DEVELOPMENT APPLICATION ASSESSMENT REPORT

Application Number:	DA2024/1206
----------------------------	-------------

Responsible Officer:	Jordan Howard
Land to be developed (Address):	Lot 18 DP 19022, 107 Iris Street BEACON HILL NSW 2100
Proposed Development:	Two stage subdivision of one lot into three lots including driveway and associated works
Zoning:	Warringah LEP2011 - Land zoned R2 Low Density Residential
Development Permissible:	Yes
Existing Use Rights:	No
Consent Authority:	Northern Beaches Council
Land and Environment Court Action:	No
Applicant:	Maree Jaloussis Hayes

Figure 1 - Proposed Subdivision Plan

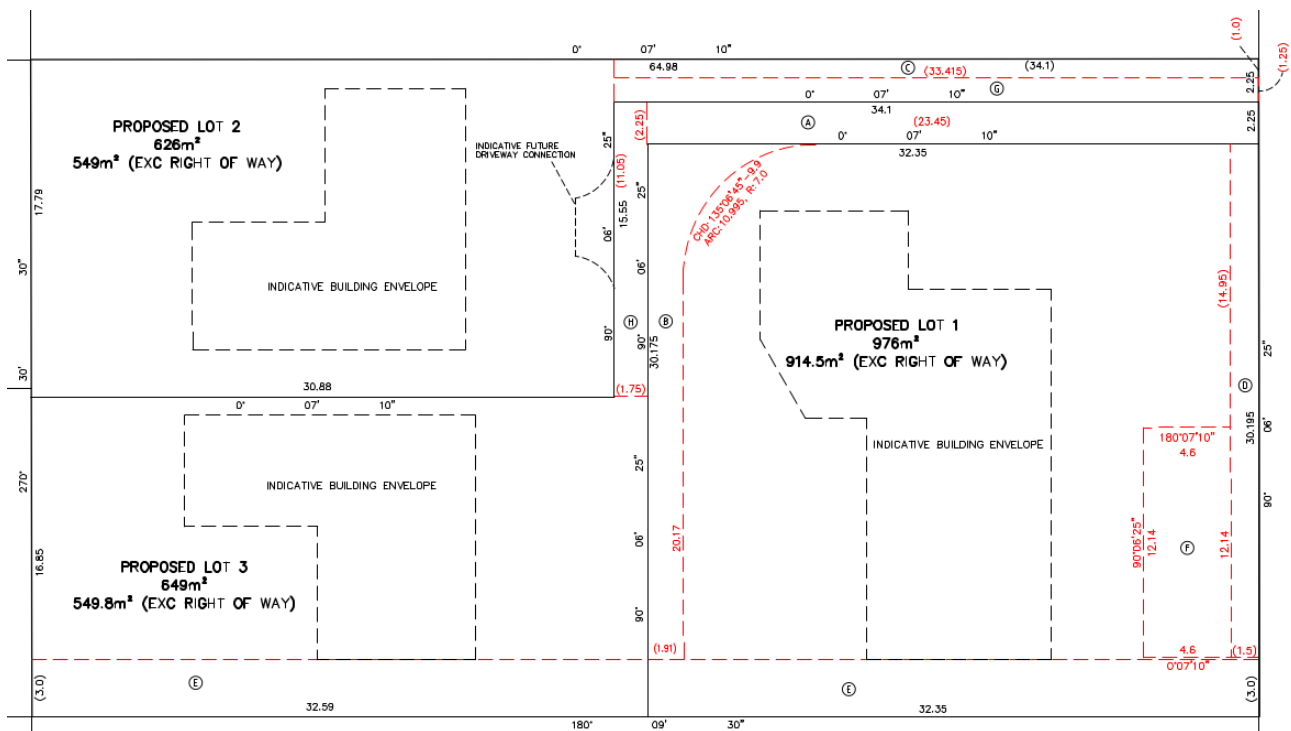
Note that WLEP 2011 Clause 4.1 Minimum subdivision lot size stipulates that when calculating the size of a lot area, any access corridor (including any right of carriageway, access way or other area that provides for vehicle access) is to be excluded. Furthermore, this assessment reflects the end result after Stage 2.

The proposed Stage 1 development (subdivision of Lot 1 closest to Iris Street) will not result in allotments smaller than the minimum lot size.
